ENGINEERING PRACTICE STUDY

TITLE: MIL-PRF-28750/9, REPLACING FIGURE 5. BROADBAND CONDUCTED EMISSIONS WITH MIL-STD-461F FIGURE CE102-1. CE102 LIMIT (EUT POWER LEADS, AC AND DC) FOR ALL APPLICATIONS.

FINAL REPORT

Project Number: 5945-2015-022

Current MIL-PRF-28750/9 FIGURE 5. Broadband conducted emissions.

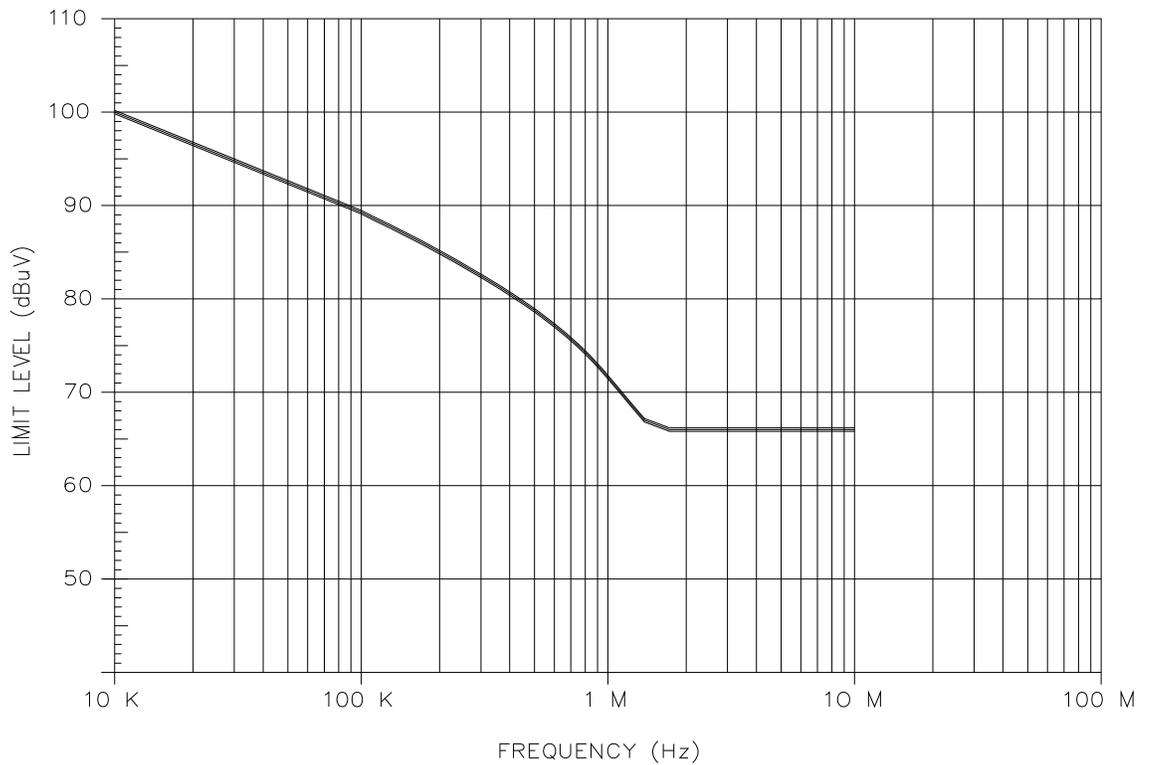
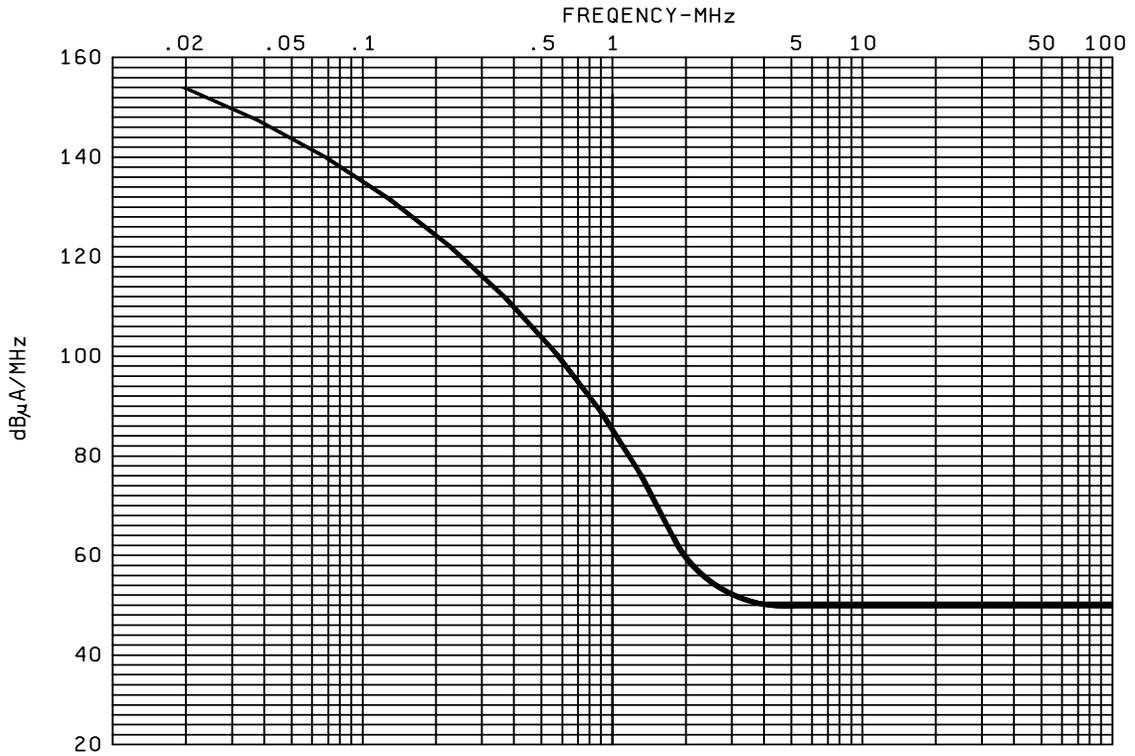
- A. Determine the acceptability of replacing MIL-PRF-28750/9 FIGURE 5 from the current Broadband conducted emissions. to MIL-STD-461F Figure CE102-1. CE102 limit (EUT power leads, AC and DC) for all applications. to support the electromagnetic interference measurement.

- II. **BACKGROUND:** DLA Land and Maritime was notified of the manufacturer's inability to measure, using a Line Impedance Stabilization Network (LISN), the units or range supported by FIGURE 5 Broadband conducted emissions. It was requested FIGURE 5 be modified to reflect MIL-STD-461F FIGURE CE102 limit (EUT power leads, AC and DC) for all applications. to support the obtainable electromagnetic interference measurement.

- III. **RESULTS:** A survey letter was sent to all QPL manufacturers and document custodians/reviewers. The response supported eliminating the existing FIGURE 5 Broadband conducted emissions. As a result, MIL-PRF-28750/9, FIGURE 5 will be replaced with MIL-STD-461F Figure CE102-1. CE102 limit (EUT power leads, AC and DC) for all applications. MIL-PRF-28750/10, FIGURE 5 will be replaced with MIL-STD-461F Figure CE102-1. CE102 limit (EUT power leads, AC and DC) for all applications., using relaxed requirements. Figure 5 will be renamed Conducted emissions.

- IV. **CONCLUSIONS:** It was determined DLA Land and Maritime will update MIL-PRF-28750/9 and MIL-PRF-28750/10 to use MIL-STD-461F Figure CE102-1. CE102 limit (EUT power leads, AC and DC) for all applications. as Figure 5 to reflect obtainable measurements. For MIL-PRF-28750/9, MIL-STD-461F Figure CE102-1. CE102 limit (EUT power leads, AC and DC) for all applications will be implemented, as stated. For MIL-PRF-28750/10, MIL-STD-461F Figure CE102-1. CE102 limit (EUT power leads, AC and DC) for all applications will be implemented, with relaxed requirements. See Attachment A.
